# Town Center Subarea Plan Public Comments and Responses

CITY OF  
**MOUNTLAKE  
TERRACE**

**Public Open House –December 4, 2018**

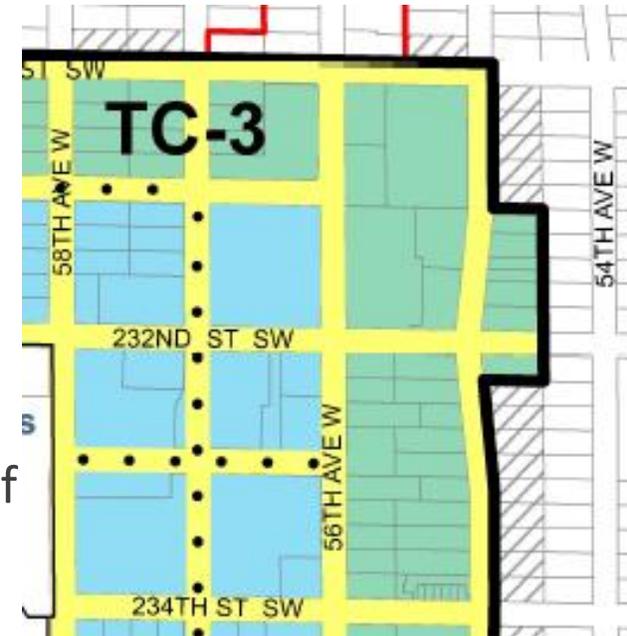
6. The “bulb out” on 55<sup>th</sup> does not provide neighbors with a transition in height. Suggestion to grandfather existing business and limit future expansion.

**Staff Response:** Also a concern of residents at the open house. Staff suggest the removal of the “bulb out” as stated in Open House Comment #3.
